UNITED STATES PATENT AND TRADEMARK OFFICE

Office Action Summary	Application No.	Applicant(s)
	10/666,431	TANASE ET AL.
	Examiner BASIL KATCHEVES	Art Unit 3635

DETAILED ACTION

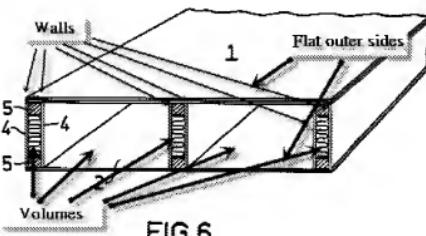
Regarding claim 29 and 31, Thorn discloses a panel with two flat outer sides, a plurality of partition walls (4) between the sides, the walls defining hollow volumes within, and at least one volume contains a solid rod (5), the panel inherently capable of making a non uniform frequency through the panel (see marked fig. below).

Regarding claims 29 and 32, Thorn discloses a panel with two flat outer sides, a plurality of partition walls between the sides, the walls defining hollow volumes within, and at least one volume contains a rod, the panel inherently capable of making a non uniform frequency through the panel (see marked fig. 6). Also, Thorn discloses an embodiment of two panels connected to make one larger panel (marked figure below) which discloses at least two volumes adjacent with each other that both contain a solid (5) within.

It would be an obvious design choice to add a plurality of panels since they are shown in figure above and a mere duplication of working parts is common in the art.

Regarding claim 33, Thorn discloses the rod like members (5) as traversing, in a sectional view as shown above, in a perpendicular manner (left to right or right to left) from the walls which bound them.
